# FTI-NSP2 Type 2 - Installation Notes & Wiring Diagram

**Overview:** The initial production release of the FTI-NSP2 harness has an issue where the POC1 circuit is incorrectly positioned in the CM7 I/O connector. This issue affects only the gray 20-pin CM7 I/O connector illustrated below in figure 1.

*Figure 1: Incorrect placement*

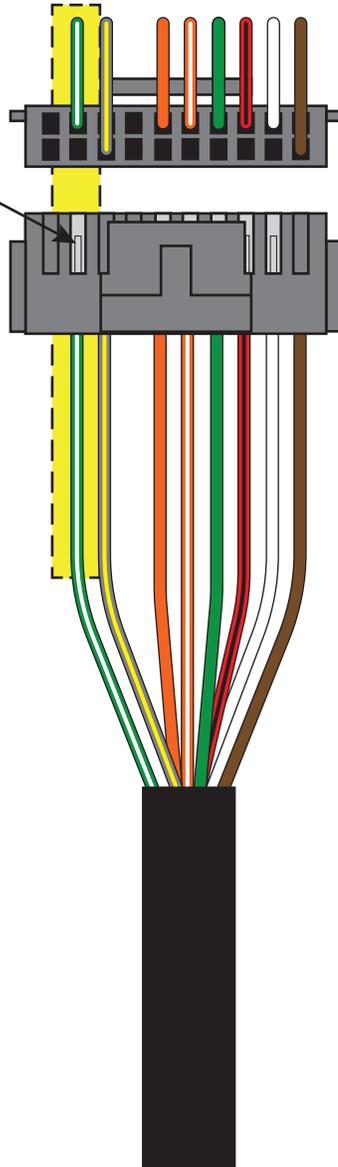
**Issue:** The green/white parking light circuit is positioned in pin position #17, the fixed light output where the green/white wire is typically placed for parking lights, but the harness solution uses the vehicle hazard lights instead, the result when used as supplied is an erratic light display.

- 1.) Use a pick tool to depress the locking tab on the terminal connector of the green/white wire
- 2.) Remove wire and prepare to reposition
- 3.) Once removed, reposition the locking tab by using a razor knife to lift the tab into a usable position
- 4.) With locking tab repositioned, relocate to pin position #1 (top right position as illustrated)
- 5.) Push the terminal connector into the I/O connector housing until the locking tab clicks into place and the wire is secure
- 6.) Correction complete, you may now complete the installation, but remember to configure POC1 for Hazards (setting #30)

*Figure 2: Corrected placement*
